September 17, 1992

LICENSEE: Florida Power Corporation (FPC)  
FACILITY: Crystal River, Unit 3 (CR-3)  
SUBJECT: SUMMARY OF AUGUST 13, 1992, FPC/NRC MEETING  
ON PROCUREMENT INSPECTION AT CR-3

# Critical Characteristics

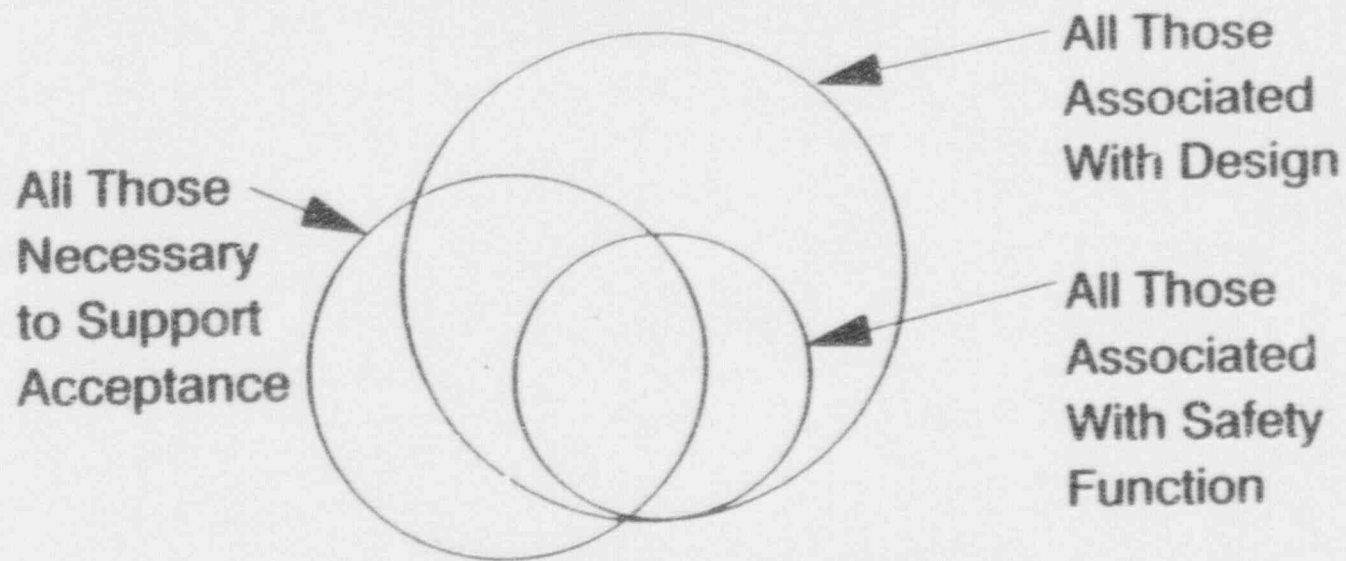
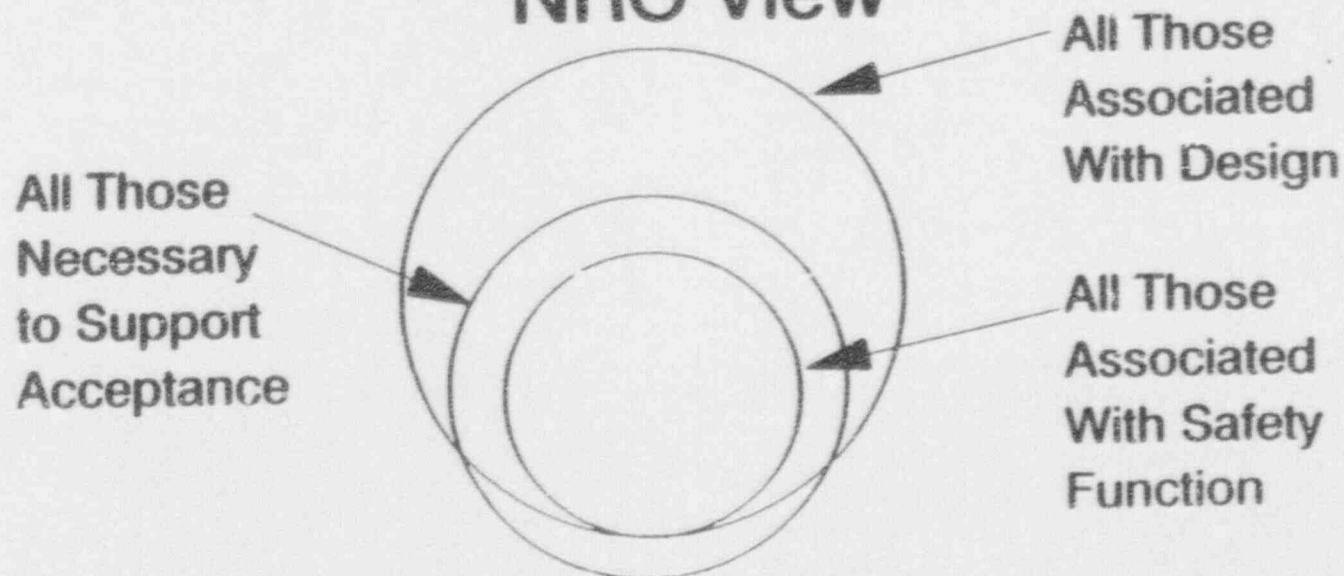
THIS IS THE MOST IMPORTANT AND FUNDAMENTAL ISSUE FACING FPC AND THE INDUSTRY IN GENERAL. IT CAN BE SUMMARIZED AS SHOWN ON THE ATTACHED FIGURE AND ASSOCIATED NOTES. ALTERNATIVELY, THE QUESTION CAN BE STATED AS:

IS IT NECESSARY TO IDENTIFY AND VALIDATE ALL CRITICAL CHARACTERISTICS RELATED TO A COMPONENTS SAFETY FUNCTION; OR, IS THERE A SUBSET OF CHARACTERISTICS NECESSARY AND SUFFICIENT FOR ACCEPTANCE?

FPC AND THE INDUSTRY BELIEVES ONE CAN IDENTIFY A SET OF CHARACTERISTICS TO ACHIEVE DEMONSTRATION OF SUITABILITY FOR APPLICATION WITHOUT VALIDATING ALL THOSE ASSOCIATED WITH SAFETY FUNCTION. BOTH THE NRC AND THE INDUSTRY AGREE THAT NOT ALL THOSE ASSOCIATED WITH A COMPONENTS DESIGN MUST BE VALIDATED.
